### REMARKS

Application No. 10/083,760  
Amendment dated June 8, 2004  
Reply to Office Action dated April 27, 2004

Fig.2

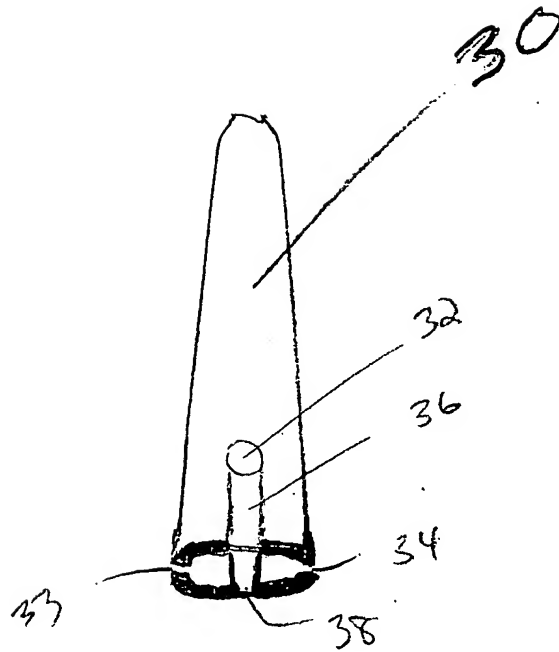
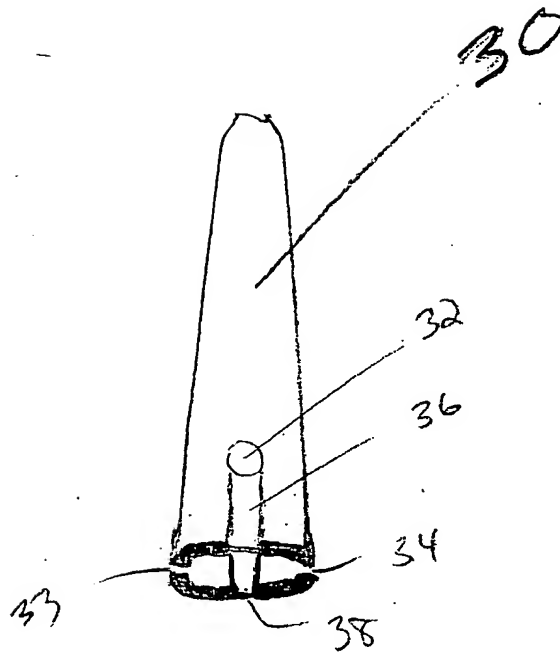
In paragraph 2 of the Office Action, the Examiner has objected to the drawings under 37 CFR 1.83(a) because the rivet head channel is not shown in the drawings.

Upon review of Fig. 2, rivet back channel 38, although partially illustrated, is not shown in full. Rivet back channel 38 as described on page 6, paragraph [0015] of the specification, is similar to rivet head channel 36 except that it is located on the back side of cover 30.

As shown in Fig. 2, the reduced thickness at the open end of cover 30 is shown for rivet head channel 38, but the rest of the channel extending up towards the closed end of cover 30 was inadvertently not shown. As such, Applicant has amended Fig. 2 to show rivet back channel 38 extending away from the open end of cover 30 towards the closed end of cover 30, until it disappears behind the top of cover 30. This amendment Fig. 2 more clearly illustrates the element as described and more closely corresponds to the other rendition of rivet back channel 38 shown in Fig. 4.

This feature of a rivet head channel is shown in Fig. 2, properly identified as

element 36, where a channel is shown extending from the open end of the cover to the rivet head receiving slot 32. Additionally, the angled front view of figure 2 shows the open end of cover 30 having a first thickness and the rivet head channel 36 having a second lesser thickness. The rivet head channel is also illustrated in different views in both Figs. 3 and 4.

In view of the foregoing, Applicant respectfully submits that the Amended Fig. 2 properly shows all of the described and claimed elements and requests that the objection to the drawings be withdrawn. Applicant further notes that pages 5 and 6 of the specification adequately support the drawings amendments, and that no new matter has

Fig. 4

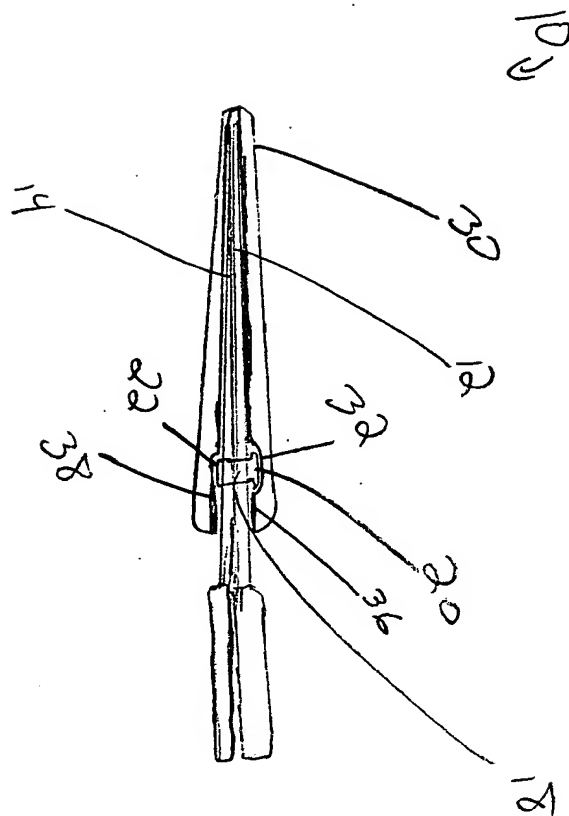
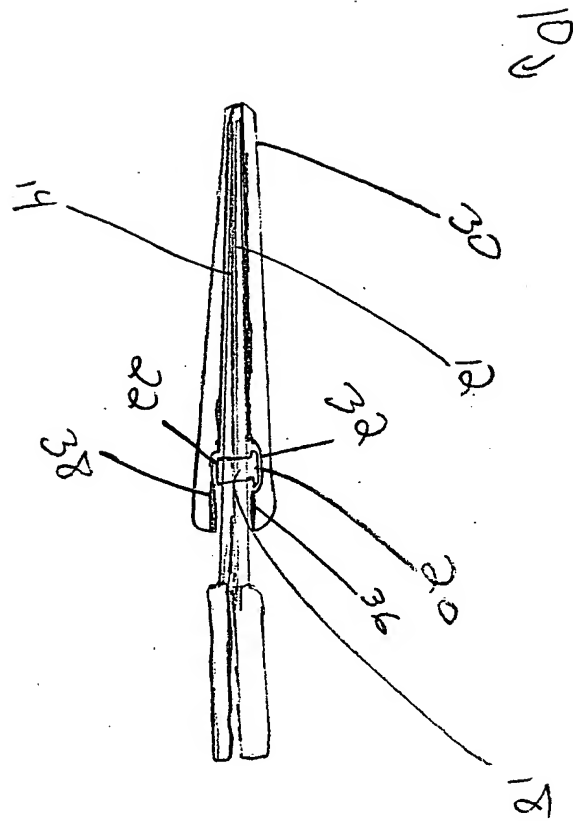
In paragraph 1 of the Office Action, the Examiner has objected to the specification because the element identifier “22”, on page 5 is missing from the drawings. Applicant has amended paragraph [0011] of the specification to indicate that element 22 is illustrated in Fig. 4, and the corresponding element identifier “22” has been added to Fig. 4. As such, Applicant respectfully requests that the objection to the specification be withdrawn.
